Considerations on updating Figure 154-3 and associated context

IEEE P802.3ct Task Force, Terminology Ad Hoc Call, 16 February 2021

This presentation contains considerations on and proposals for addressing concerns related to Figure 154-3 in P802.3ct D3.1, discussed during the ad hoc call on 12 February.

Figure 154–3—DWDM black link example configuration for specifying n DWDM channels

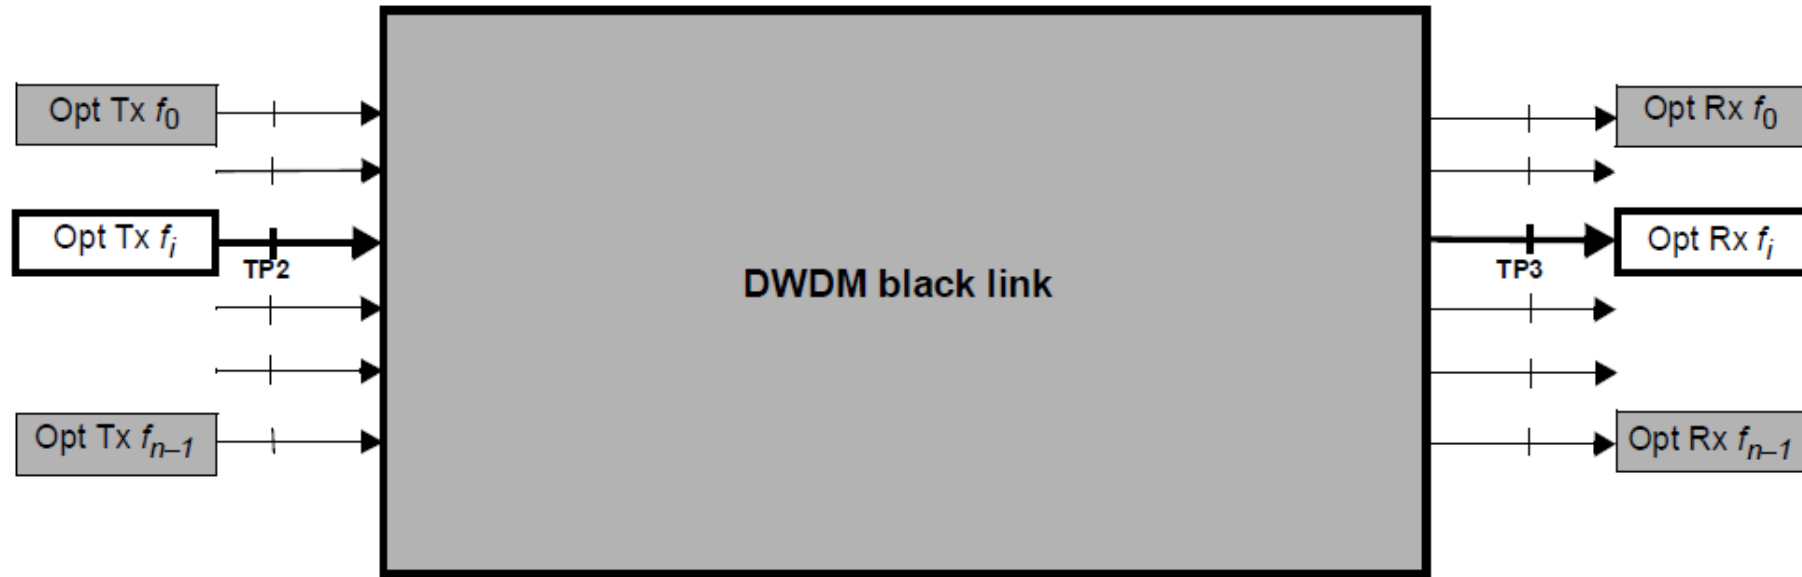
- Including a note (consistent with other PMDs) “*For clarity, only one direction of transmission is shown*”
- Potential variant with bi-directional transmission can be described in text of 154.6 or by adding a figure to informative Annex 154A.

Figure 154–3—DWDM black link example

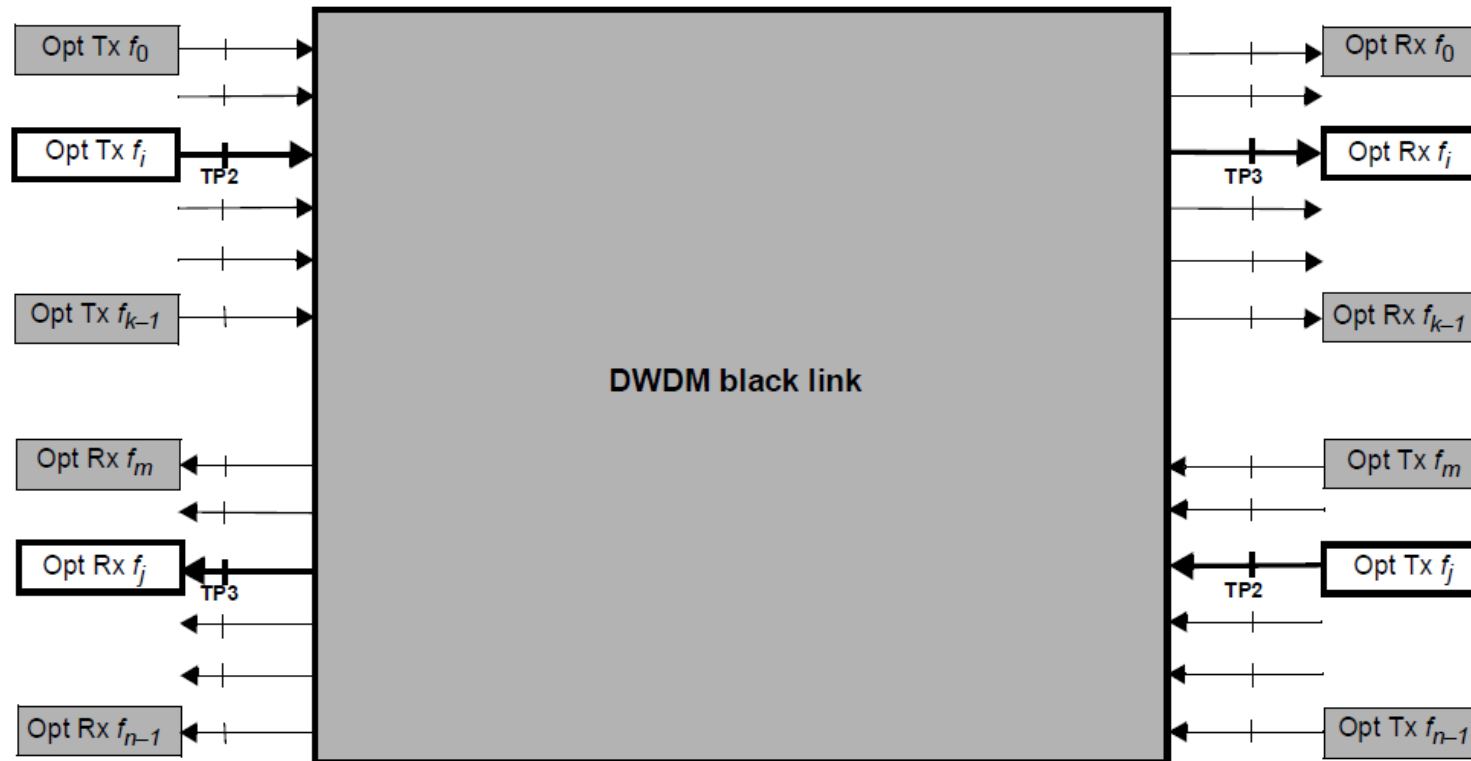
- Could add existing Figure 154-3 (with details) to informative Annex 154A.
- Potential variant with bi-directional transmission can be described in text of 154.6 or by adding a figure to informative Annex 154A.
